Title:	RN DS-76xxNI-E1(E2)P NVR v3.4.96	Version:	v3.4.96	Date:	081919
Product:	DS-76xxNI-E1(E2)P NVR Firmware	Build:	171113	Page:	1 of 22
Action Required:	None, Information Only

■ DS-76xxNI-E1(E2)P Series NVR v3.4.96_171113 USA GUI Firmware (Current Version)

- **Firmware customized from v3.4.92_170518**
- **Models affected:** DS-7604NI-E1/4P, DS-7608NI-E2/8P and DS-7616NI-E2/16P
- **Reason for upgrade:** Add and optimize functionalities for better E Series NVR performance

Figure 1, System Maintenance Window

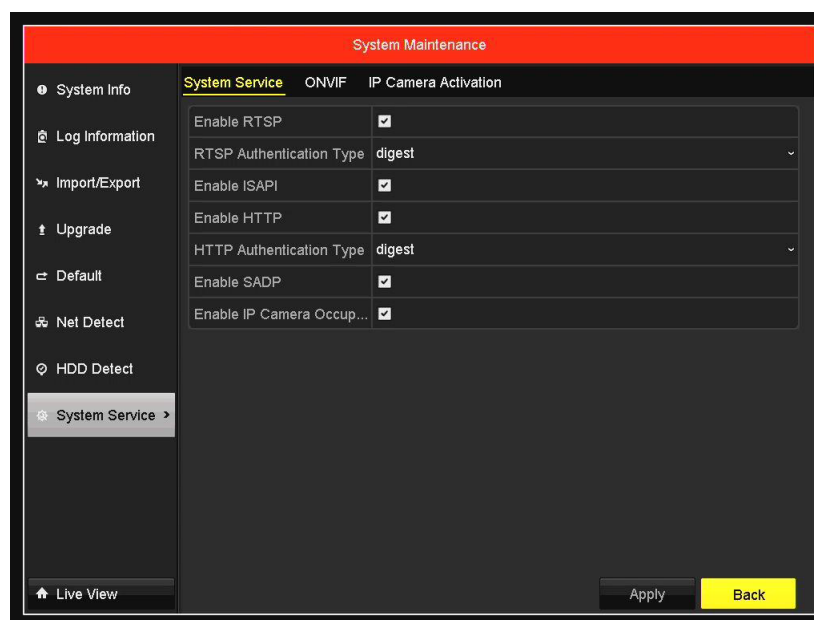
- PSIA server/client protocol removed.
- User can disable/enable RTSP protocol (only valid for server mode when client receives stream from NVR) and choose RTSP authentication type between digest, and digest and basic.
- User can disable/enable ISAPI protocol.
- User can disable/enable HTTP protocol and choose HTTP authentication type between digest, and digest and basic.
- User can disable/enable SADP protocol.

Figure 2, IP Camera Occupation Detection Box

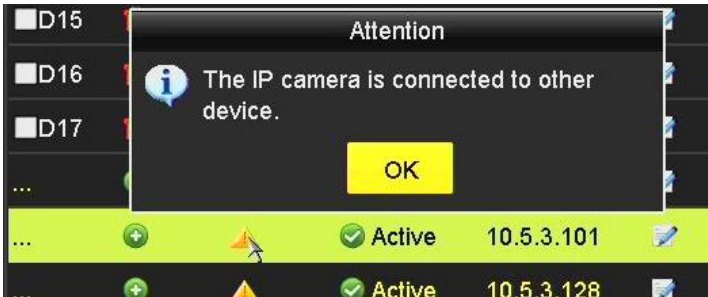
- User can disable/enable IP camera occupation detection. When this function is enabled, the NVR will detect whether the IP camera is already connected to another

device/client.

Figure 3, File Encryption Configuration Window

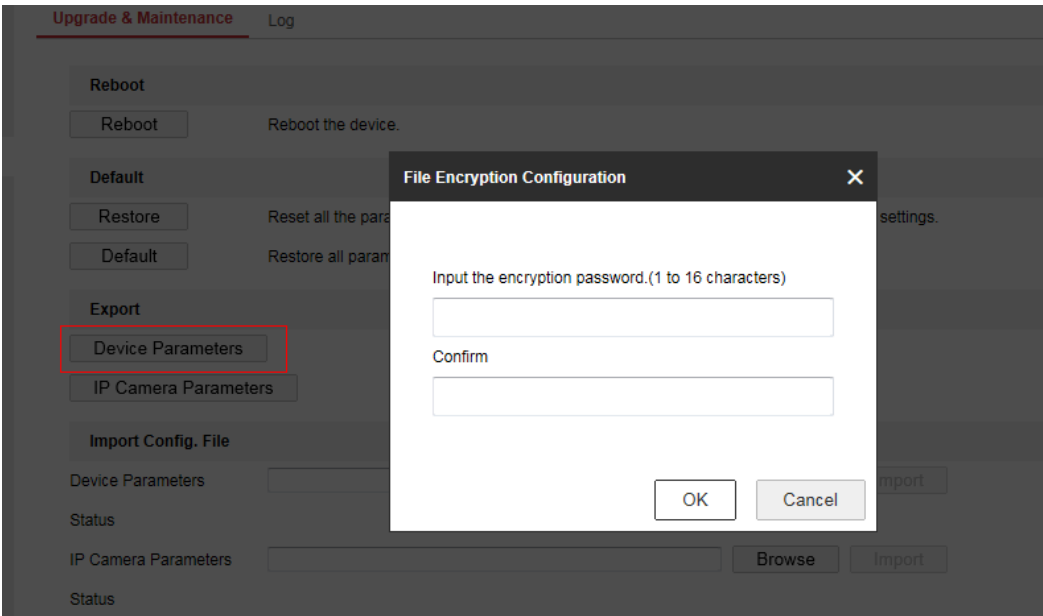
vii) The NVR device parameters will be encrypted using the user’s custom encrypt key. The encrypt key is required when a user imports it.

Figure 4, ONVIF Settings Window

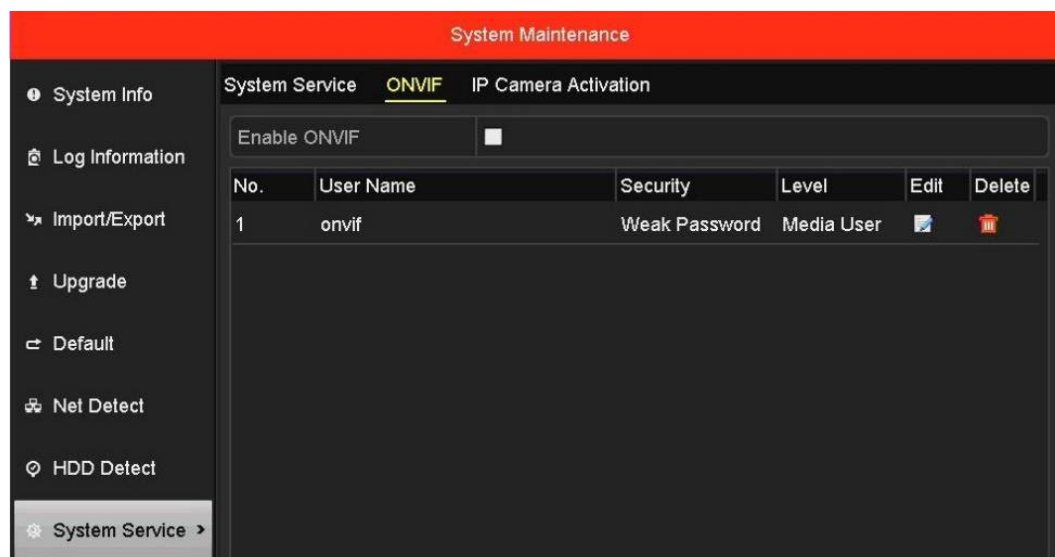
i) User can disable/enable the ONVIF protocol, and create an independent account for the ONVIF server service.

Figure 5, IP Camera Activation Window

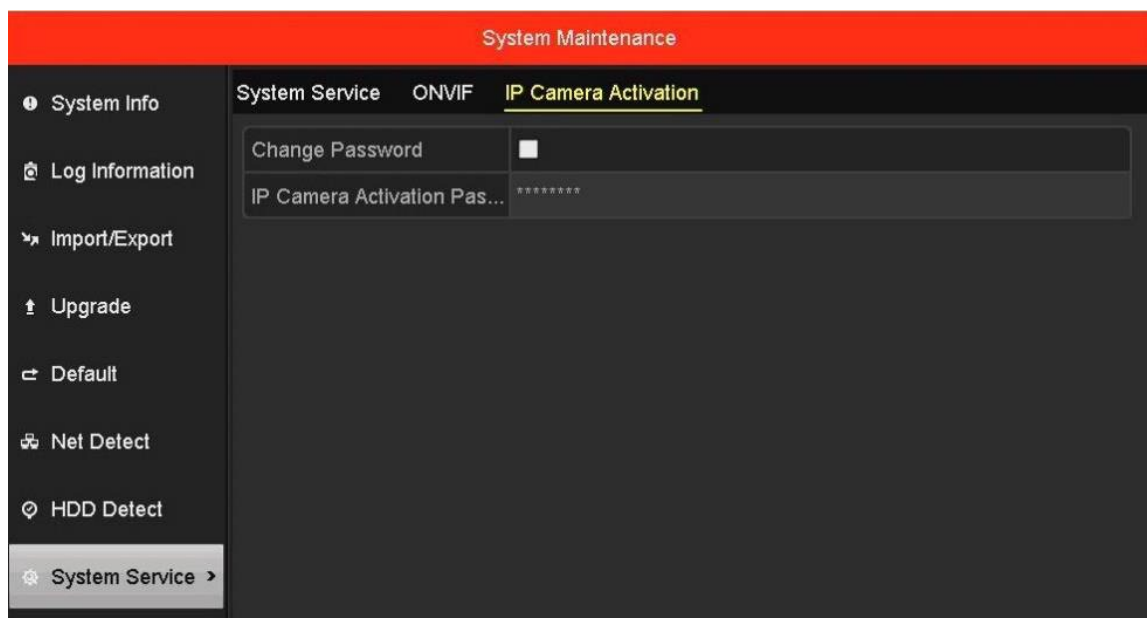
- i) In the previous version, the NVR used an admin password to activate the IP camera. From this new version, users can set the IP camera activation password independently. It does not have to be the same as the admin password.

Figure 6, PTZ 3D Function Settings

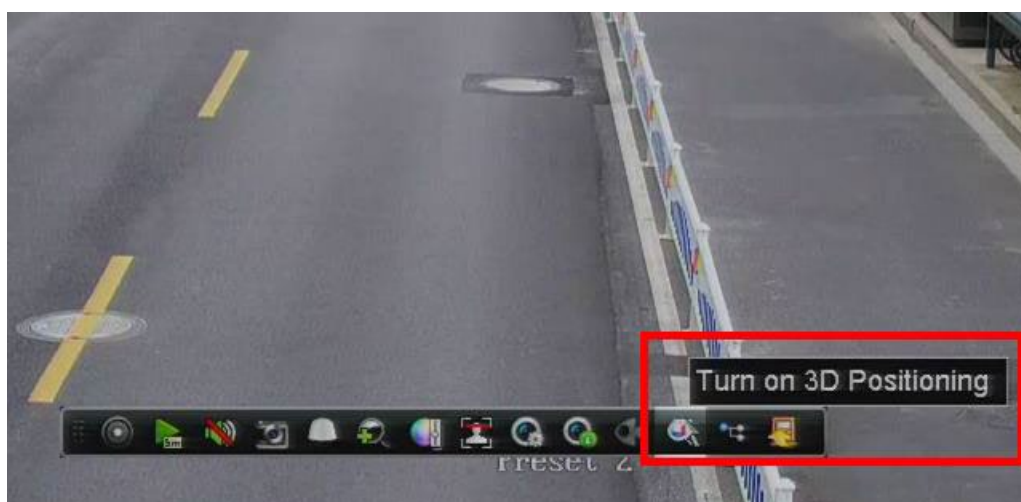
- i) 3D PTZ function control supported in the live view menu.

Figure 7, Stream Switching Settings

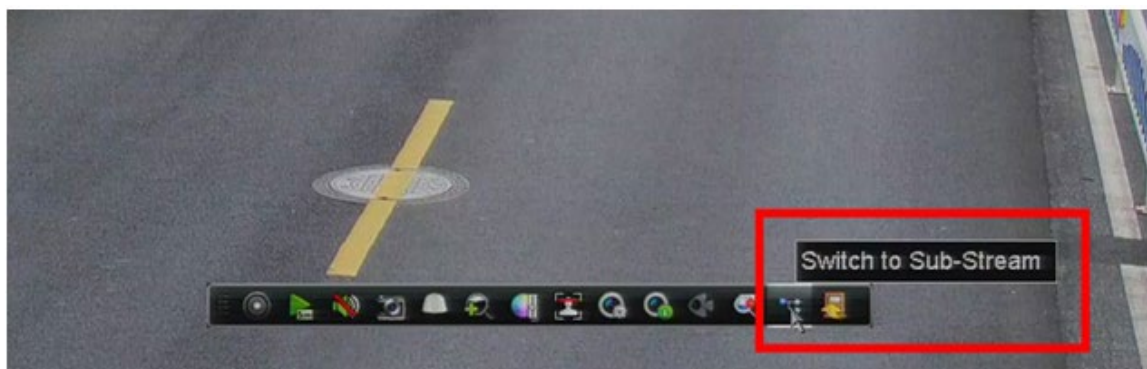
- i) The user can switch live view streams manually in the live view interface.

Figure 9, Forgotten Password Button

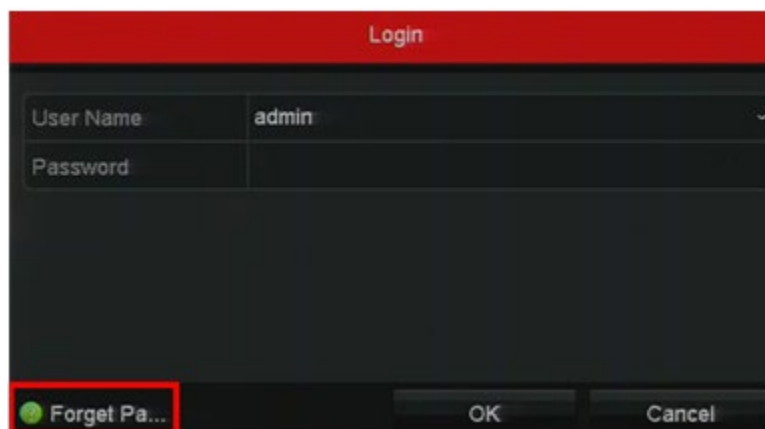
- The password resetting strategies below are only valid in the local area network. Local GUI, SADP, iVMS-4200, and Web clients support the new password strategy.
- The user can enter the new password reset interface by clicking on forget password.

Figure 12, Password Reset Questions

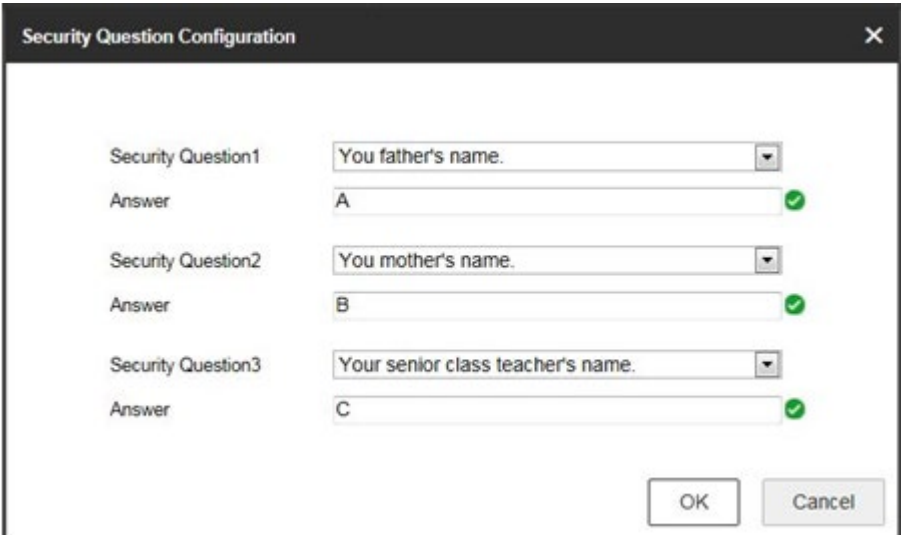
- (2) User can set validation questions and reset the password by answering the questions.

Figure 13, Open Source License Window

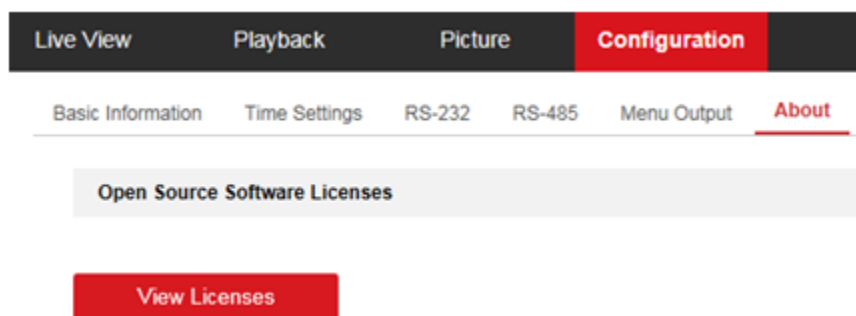
- i) GPL Open Source Software Licenses Statement added.

Figure 14, Normal Playback Screen

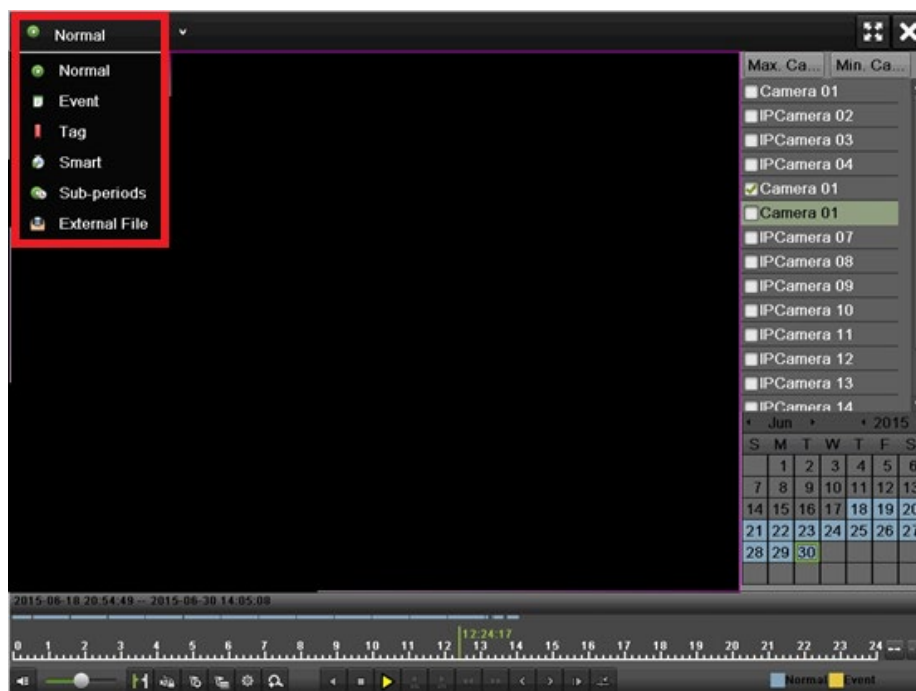
- i) Smart Playback screen removed from Normal Playback screen. Smart Playback and Normal Playback are now on separate screens.

Figure 15, Smart Playback Screen

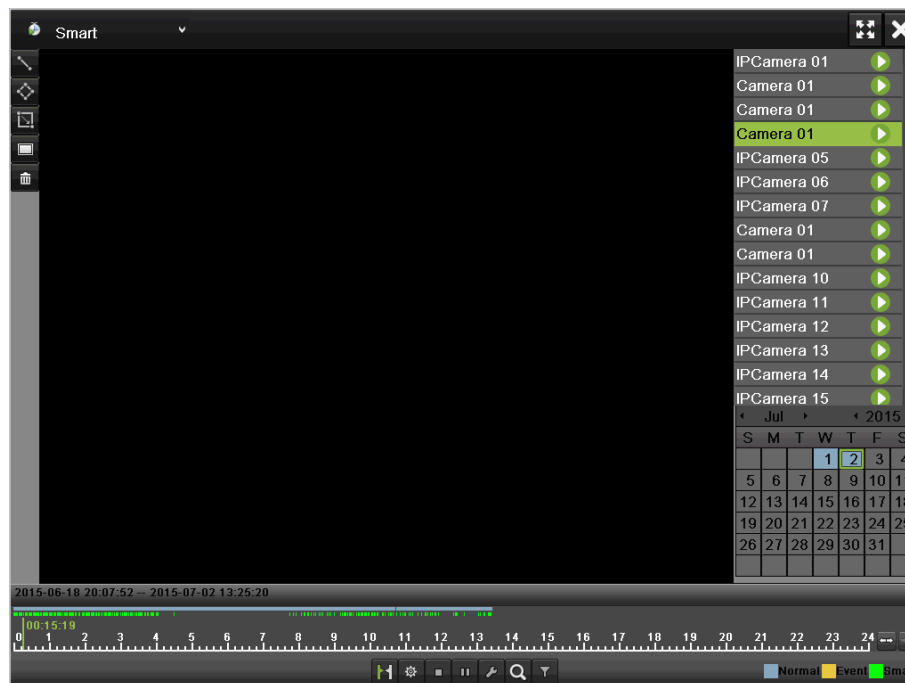
- ii) Smart Search available only while in Smart Playback mode. Smart Search is not supported during Normal Playback.

Figure 17, File Management Window

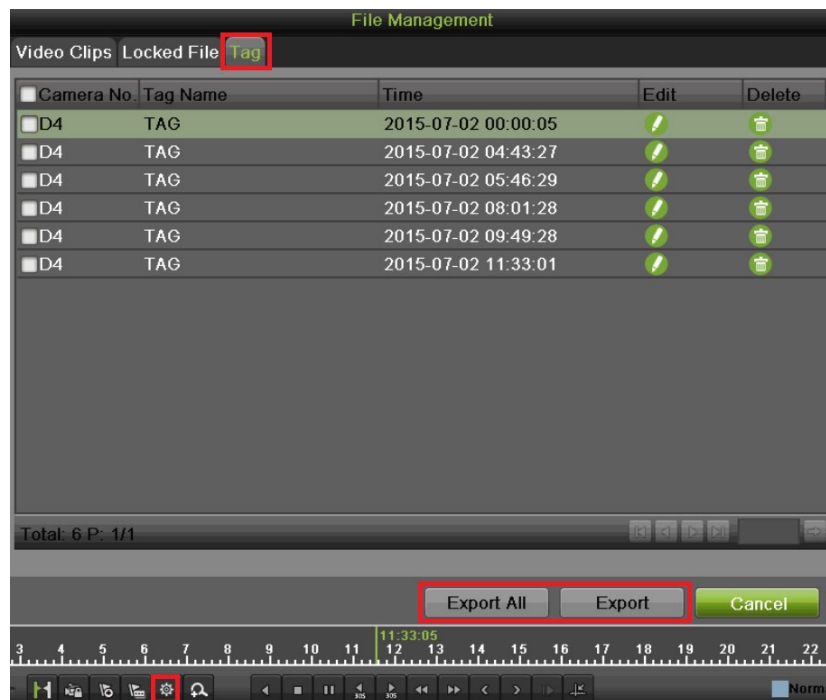
- iv) The "Export" and "Export All" buttons in the tag menu can be used to back up tag-corresponding recorded files.

Figure 18, Camera Setup Window

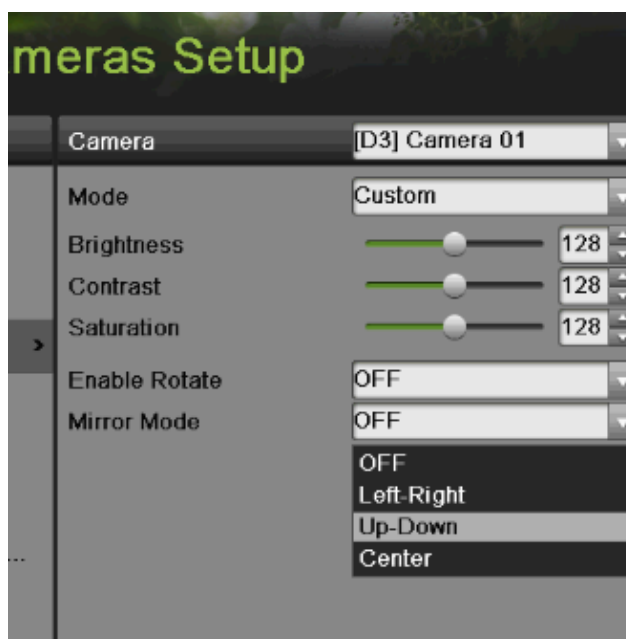
v) Rotate and Mirror modes are adjustable in Camera Setup -> Image.
